V2500 Propulsion System — Nacelle

Subject: Transmittal of Revision 3 to Service Bulletin Number V2500-NAC-71-0259

NACELLE - POWERPLANT – AIR INLET COWL – INSTALLATION OF A FAN COWL DOOR  
HOLD OPEN DEVICE

# V2500-NAC-71-0259

Installation of the Hold Open Device  
Figure 1 Sheet 1 of 2

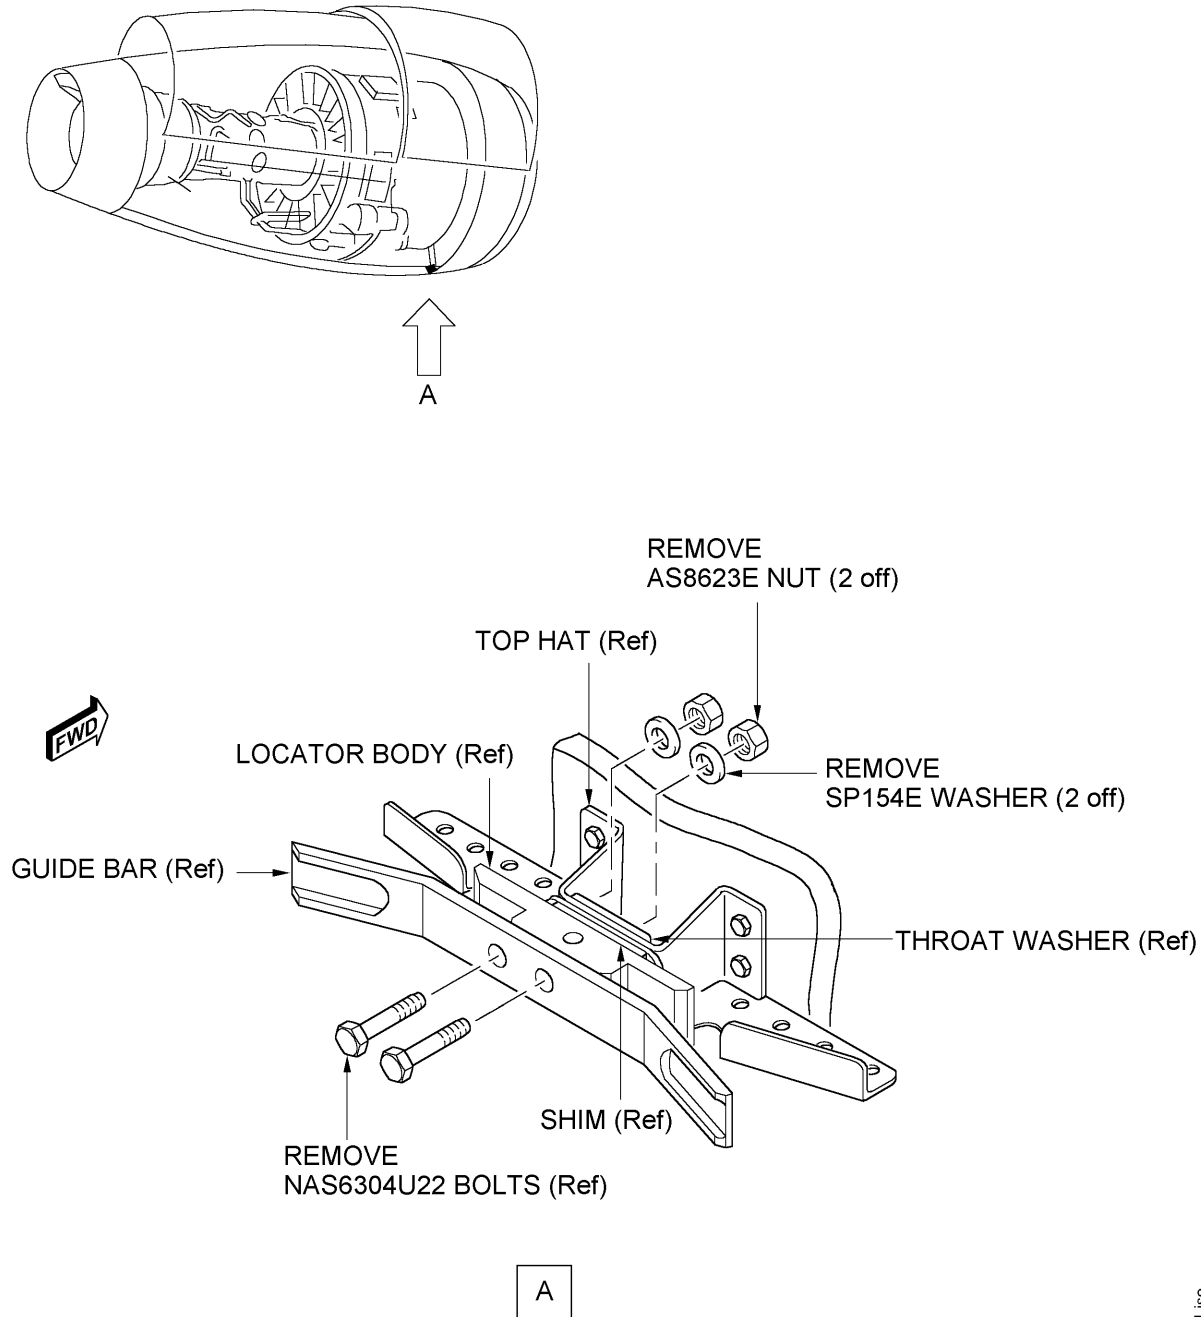
- (7) Remove the two AS8623E Nuts, the two SP154E Washers and the NAS6304U22 Bolts from the Door Locator. Refer to Figure 1, sheet 1.

**NOTE:** When you remove the two AS8623E Nuts, SP154E Washers and NAS6304U22 Bolts from the Door Locator, you must hold the Throat Washer, the Shim, the Locator Body and the Guide Bar in position.

Installation of the Hold Open Device  
Figure 1 Sheet 2 of 2

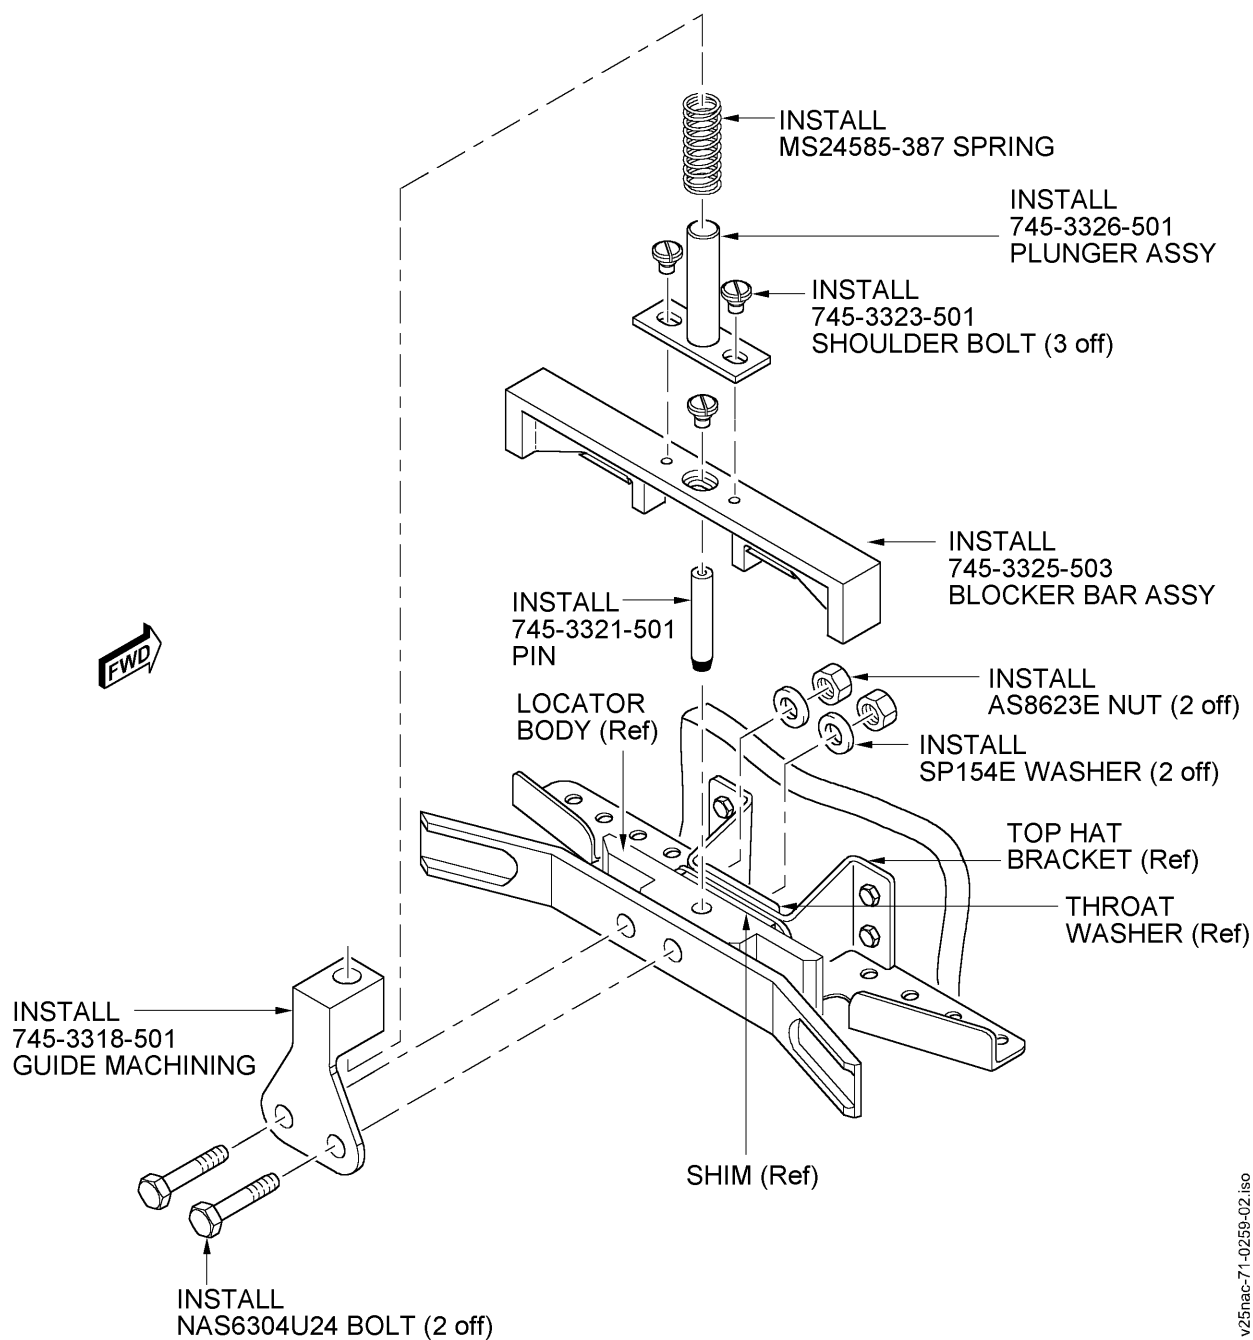
- (1) Apply two drops of CoMat 08-026 Locking Compound to the threads of the 745-3323-501 Shoulder Bolt that attaches the 745-3321-501 Pin to the 745-3325-503 Blocker Bar Assembly. Refer to Figure 1, sheet 2.

- (2) Install the 745-3321-501 Pin to the 745-3325-503 Blocker Bar Assembly with the 745-3323-501 Shoulder Bolt. Torque the Bolt to 15 lbfin (1.7 Nm).
- (3) Apply two drops of CoMat 08-026 Locking Compound to the threads of the two remaining 745-3323-501 Shoulder Bolts.

- (4) Install the 745-3326-501 Plunger Assembly to the 745-3325-503 Blocker Bar Assembly with the two 745-3323-501 Shoulder Bolts. Torque the Bolts to 15 lbfin (1.7 Nm).

- (5) Install the MS24585-387 Spring to the 745-3326-501 Plunger Assembly, as shown.
- (6) Install the 745-3325-503 Blocker Bar Assembly to the Locator Body.

- (9) Put CoMat 08-024 Jointing Compound on the mating surface of the 745-3318-501 Guide Machining as an interlay between the Guide Machining and the Guide Bar. Assemble the parts while the Jointing Compound is still wet. Refer to Figure 1, sheet 2.
- (10) Install the 745-3318-501 Guide Machining to the 745-3326-501 Plunger Assembly and the Guide Bar with the two NAS6304U24 Bolts, SP154E Washers and AS8623E Nuts, as shown. Torque the Nuts to 72 lbf·in (8.1Nm). Remove any excess Jointing Compound.
- (11) Reidentify the 740-3000-605 Air Inlet Cowl to 740-3000-609 with a metal stamp or vibro-etch engraver. Refer to the IAE/V2500 Standard Practices/Processes Manual, Chapter 70-09-00.
- (12) Reidentify the 745-3000-511 Air Inlet Cowl to 745-3000-515 with a metal stamp or vibro-etch engraver. Refer to the IAE/V2500 Standard Practices/Processes Manual, Chapter 70-09-00.

Functional check of the Hold Open Device  
Figure 2

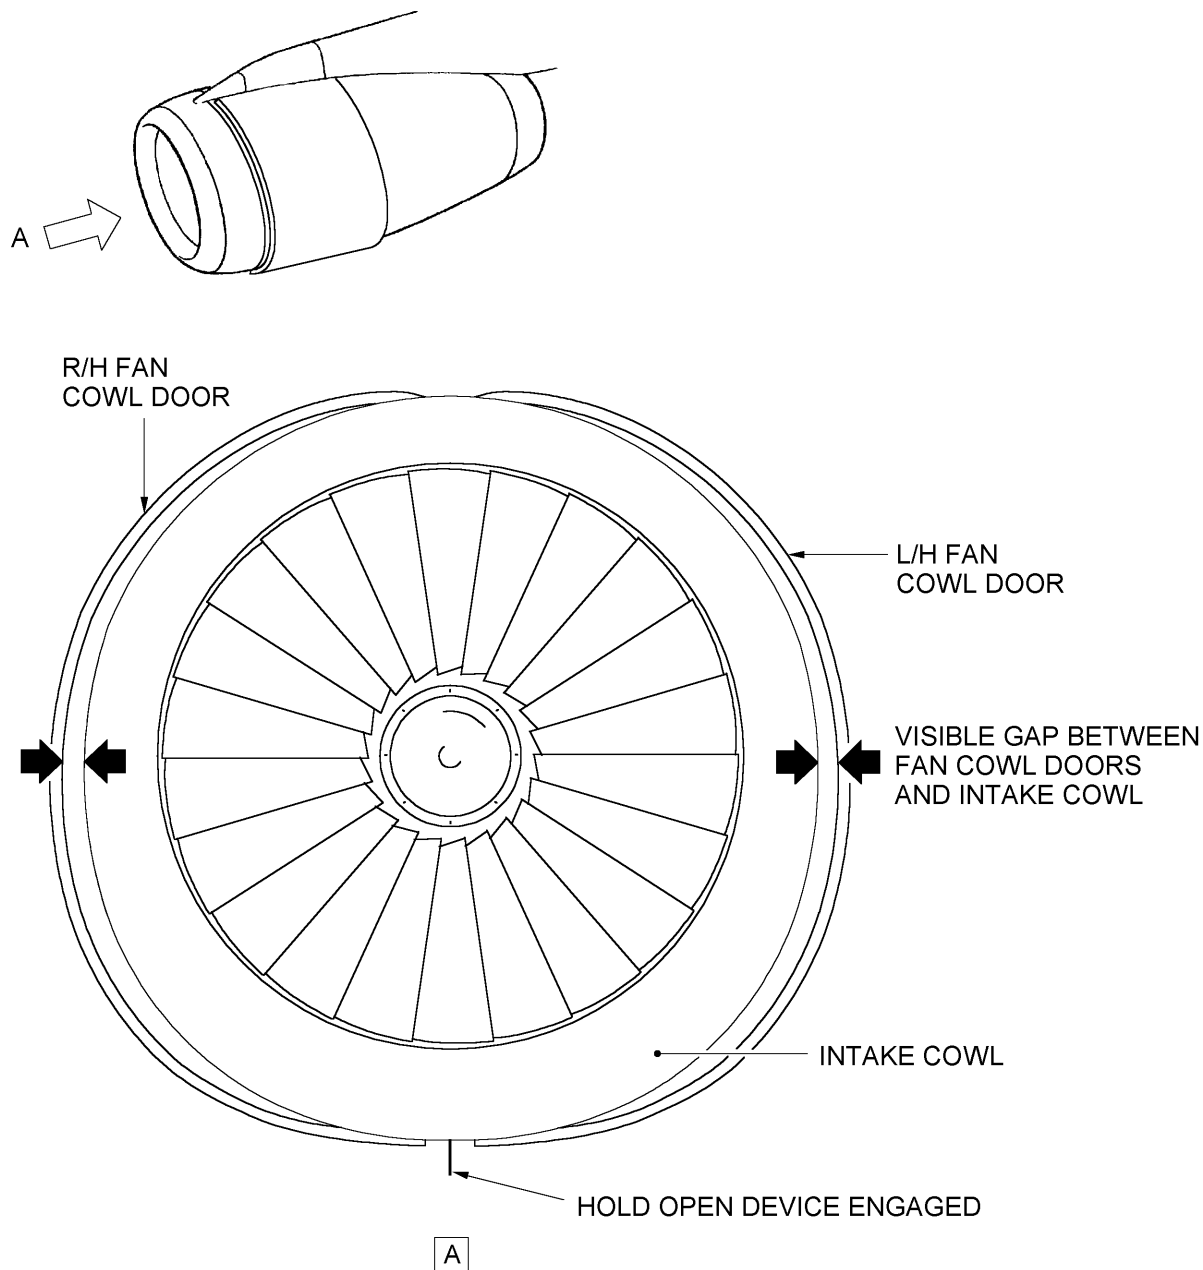
- (1) Do Subtask 71-13-00-860-051 as instructed in A320/V2500-A1, A319/A320/A321/V2500-A5 Aircraft Maintenance Manual, Task 71-13-00-410-010.
- (2) Do Subtask 71-13-00-410-059 Steps A.(1) thru A.(6). as instructed in A320/V2500-A1, A319/A320/A321/V2500-A5 Aircraft Maintenance Manual, Task 71-13-00-410-010.
- (3) Make sure there is a visible gap between the Fan Cowl Doors and the Air Inlet Cowl at the 3 O'clock / 9 O'clock positions. Refer to Figure 2.

- (4) Use a Star-Headed ScrewDriver to push the 745-3321-501 Pin towards the Door Locator until the Fan Cowl Doors are released.
- (5) Remove the ScrewDriver from the Fan Cowl Doors.
- (6) Do Subtask 71-13-00-410-059 Steps A.(7) thru A.(12) as instructed in A320/V2500-A1, A319/A320/A321/V2500-A5 Aircraft Maintenance Manual, Task 71-13-00-410-010.
- (7) Release the four latches in sequence from the front of the Cowl to the rear.

- (8) Open the L/H Fan Cowl Door until the Door is disengaged from the H.O.D.
- (9) Lower the Fan Cowl Door.
- (10) Make sure there is a visible gap between the L/H Fan Cowl Door and the Air Inlet Cowl at the 3 O'clock position.
- (11) Use a Star-Headed ScrewDriver to push the 745-3321-501 Pin towards the Door Locator until the Fan Cowl Door is released.
- (12) Remove the ScrewDriver from the Fan Cowl Doors.
- (13) Open the R/H Fan Cowl Door until the Door is disengaged from the H.O.D.
- (14) Lower the Fan Cowl Door.
- (15) Make sure there is a visible gap between the R/H Fan Cowl Door and the Air Inlet Cowl at the 9 o'clock position.
- (16) Use a Star-Headed ScrewDriver to push the 745-3321-501 Pin towards the Door Locator until the Fan Cowl Doors are released.
- (17) Remove the ScrewDriver from the Fan Cowl Doors.

Removal and rework of Hold Open Device  
Figure 3, sheet 1

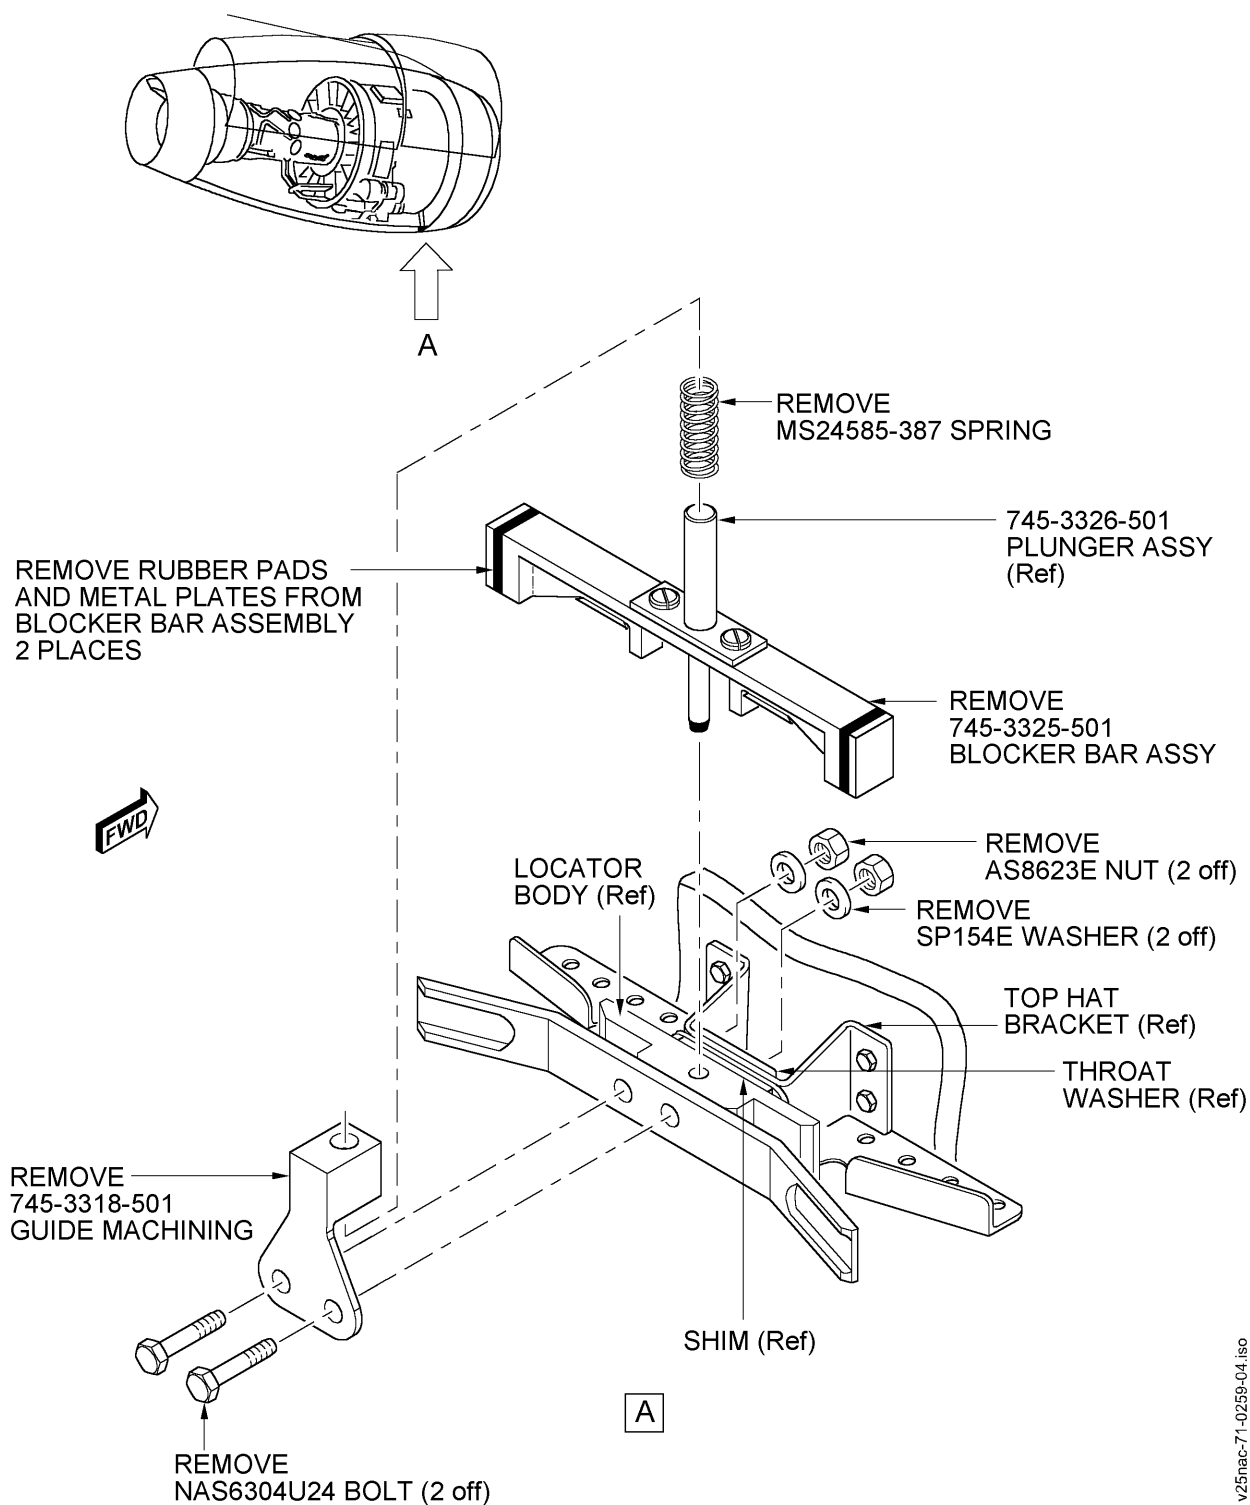
- (1) Remove the two AS8623E Nuts, the two SP154E Washers and the NAS6304U24 Bolts from the Door Locator. Refer to Figure 3, sheet 1.
- NOTE: When you remove the two AS8623E Nuts, SP154E Washers and NAS6304U24 Bolts from the Door Locator, you must hold the Throat Washer, the Shim, the Locator Body and the Guide Bar in position.
- (2) Remove the 745-3318-501 Guide Machining and MS24585-387 Spring from the Air Inlet Cowl.
- (3) Remove the 745-3325-501 Blocker Bar Assembly from the Air Inlet Cowl.
- (4) Remove the Rubber Blocks and Metal Plates from the ends of the Blocker Bar Assembly.

Installation of the Hold Open Device  
Figure 3, sheet 2

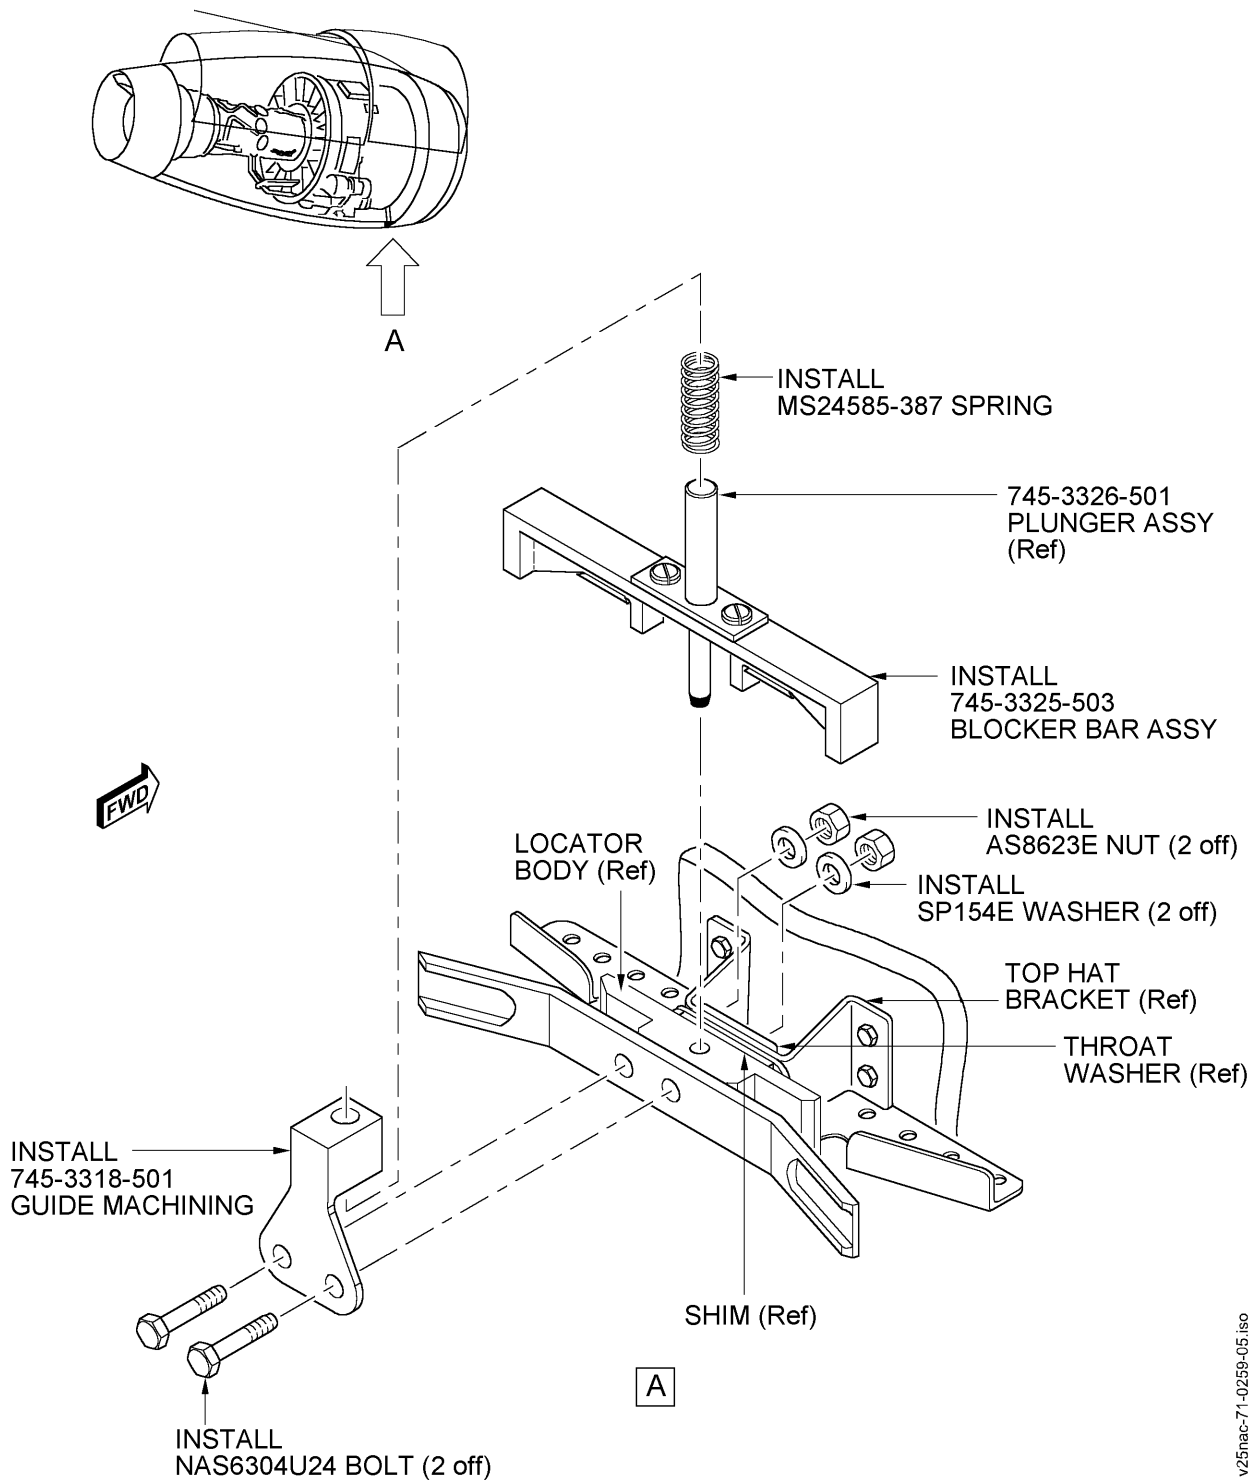
- (5) Use a clean, lint free cloth dampened with CoMat 01-076 Solvent to remove all old sealant, oil, grease, dirt or other contaminants from the exposed ends of the Blocker Bar Assembly and the mating surfaces between the 745-3318-501 Guide Machining and the Guide Bar. Wipe the area dry with a clean, lint free cloth before the CoMat 01-076 evaporates.
- (6) Reidentify the 745-3325-501 Blocker Bar Assembly to 745-3325-503 with a vibro-etcher. Refer to the IAE V2500 Standard Practices/Processes Manual, Chapter 70-09-00.
- (7) Install the 745-3325-503 Blocker Bar Assembly to the Air Inlet Cowl. Refer to Figure 3, sheet 2.
- (8) Install the MS24585-387 Spring to the 745-3326-501 Plunger Assembly.

- (9) Put CoMat 08-024 Jointing Compound on the mating surface of the 745-3318-501 Guide Machining as an interlay between the Guide Machining and the Guide Bar. Assemble the parts while the Jointing Compound is still wet.
- (10) Install the 745-3318-501 Guide Machining to the 745-3326-501 Plunger Assembly and the Guide Bar with the two NAS6304U24 Bolts, SP154E Washers and AS8623E Nuts, as shown. Torque the Nuts to 72 lbf·in (8.1Nm). Remove any excess Jointing Compound.
